EXXON NUCLEAR COMPANY, Inc.

January 30, 1981

Enclosed are two copies of Exxon Nuclear's responses to comments and questions of section 6 of the enclosure to your October 3, 1980 letter. This completes our responses to your environmental comments and questions on our license renewal application.

6. Lagoon

FIGURE 6.8-1

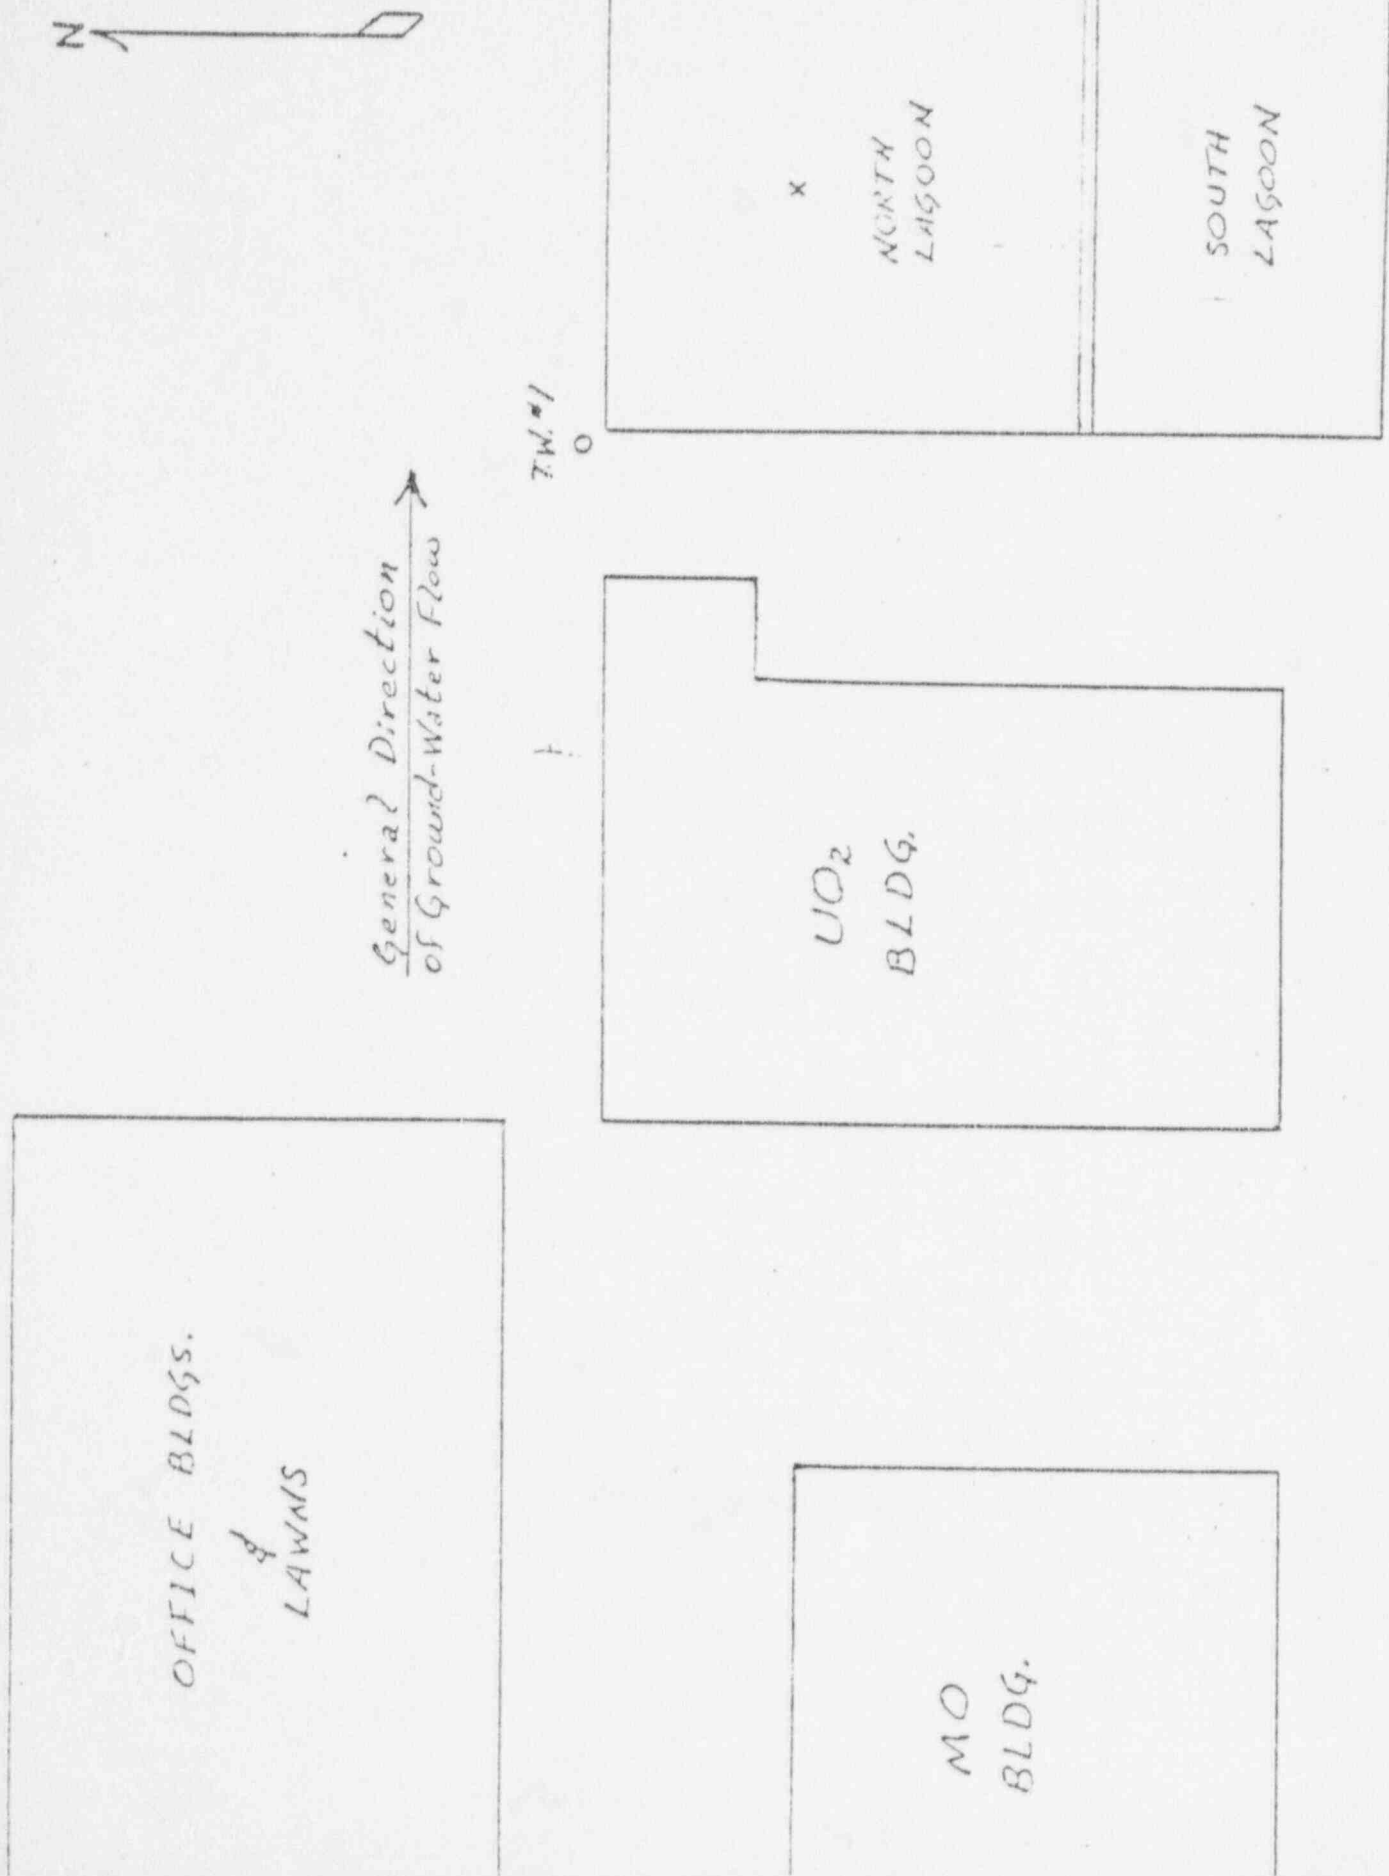
Assuming the isopiestic lines on the accompanying sketch are reasonably accurate and the flow of the unconfined aquifer is normal to these lines, a pure northwesterly flow component seems indicated in the lagoon area than has been mentioned previously. Readings taken at test wells 1, 2, and to a lesser degree, test well 11 seem to lend verification to the presence of this northwesterly flow. The question then is, what contaminants in what quantities could be migrating northwestward between test wells 1 and 11?

Further, historical data and information concerning test well sample results and observed defects in lagoon liners support the data presented above. For example, in 1973, analytical results of test well samples indicated that there was a leak from the north lagoon (at that time, only lagoons 1 and 2, and test wells 1, 2, 3, 4 and 8 existed). The north lagoon was emptied, cleaned and the Petromat liner inspected. Figure 6.8-1 (attached) is a copy of a diagram from the subsequent investigation report, which shows the locations ("x" marks) of observed defects in the lagoon liner. Figures 6.8-2 through 6.8-13 show the historical chemical characteristics of groundwater samples collected from test wells 1, 2, 3 and 4.

FIGURE 6.10-1

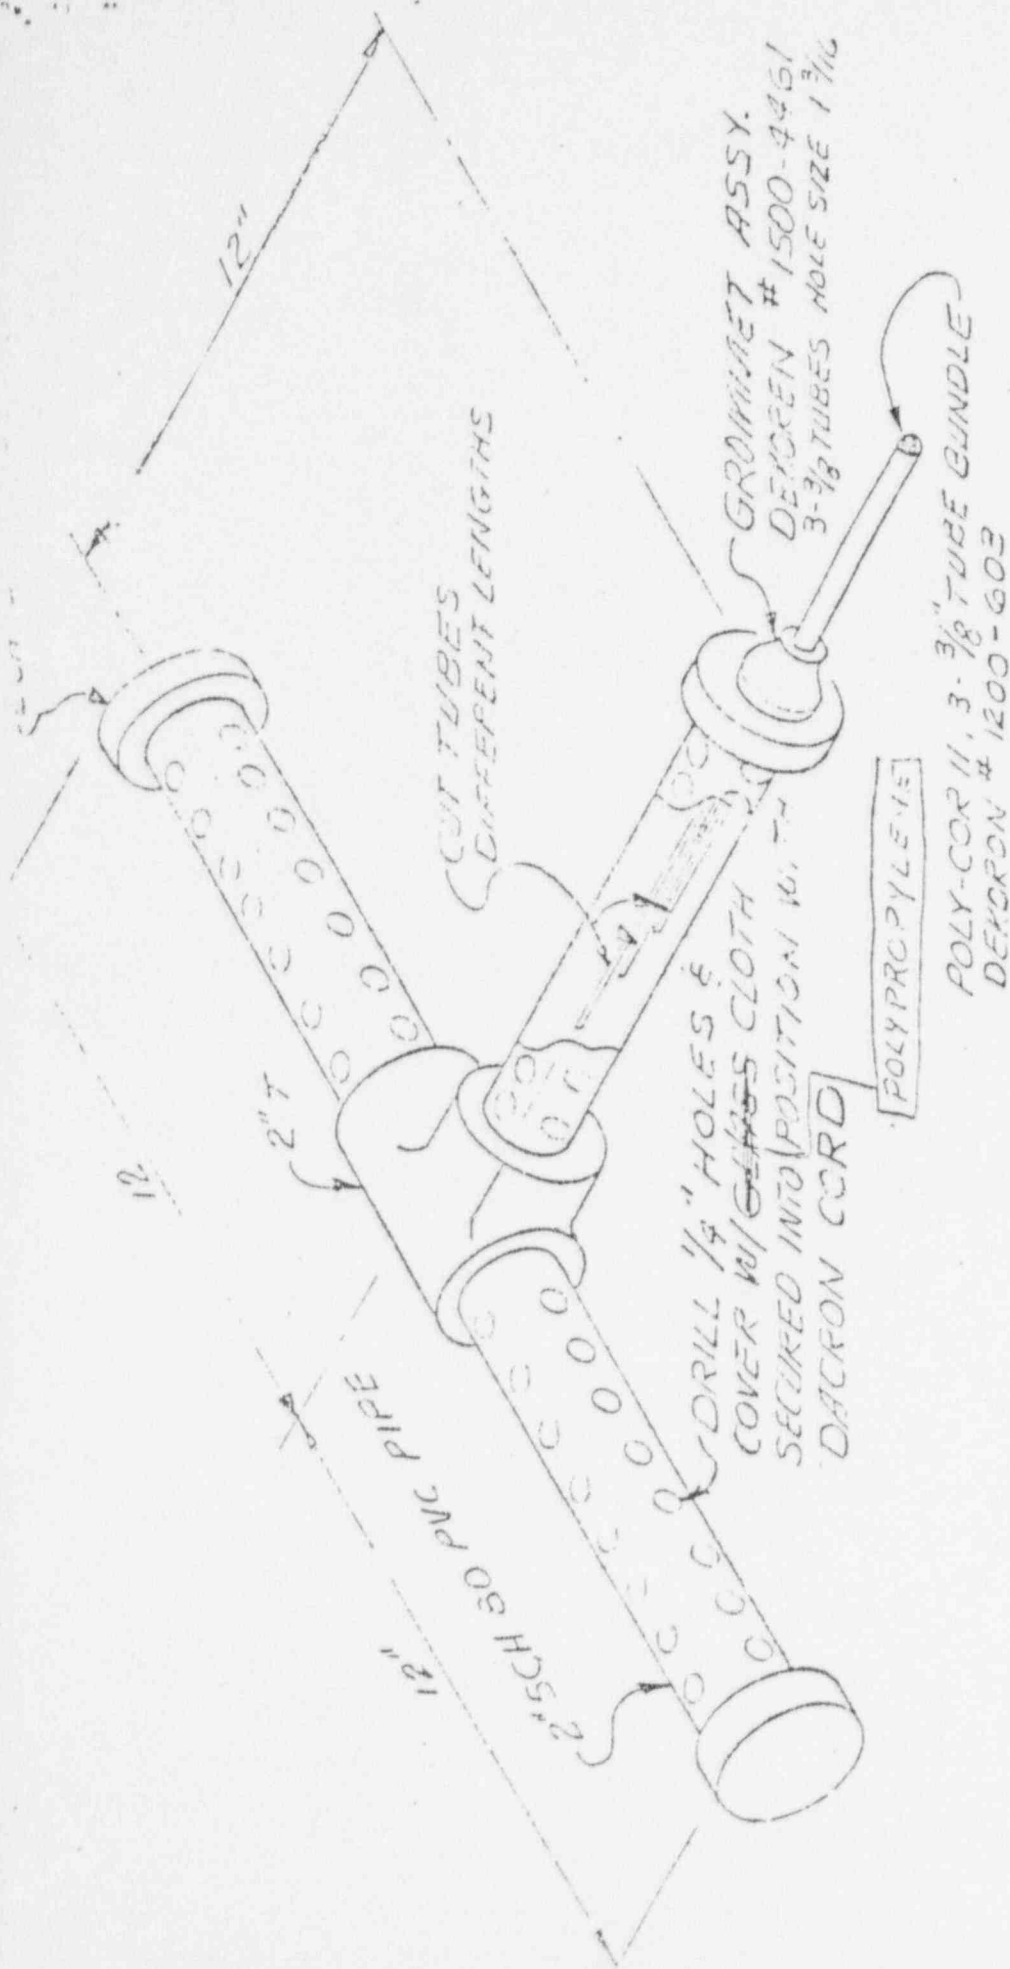
Test wells 2 and 3 have shown the presence of fluoride, nitrate and sulfur. Test wells 10, 4, 5, and 6 have indicated the presence of nitrate and well 7 the presence of sulfur. The proximity of these wells to the toe of the fills (except number 10) and the distance separating them poses the possibility of narrow contaminant plumes (narrow due to the short distances from possible release points) migrating, undetected, between the test wells along the eastern side of the lagoons. Can you describe the likelihood or probability of the well system detecting leaks assuming the upgrade between lines system does not work?

At least quarterly, a vacuum is drawn on each sampling head. If liquid is obtained from a sampling head, it is analyzed for fluoride content. The following investigative action would be initiated in the event that a significant quantity of liquid with a fluoride concentration of more than 3 mg/l should be pumped from any between-liner sampling head.
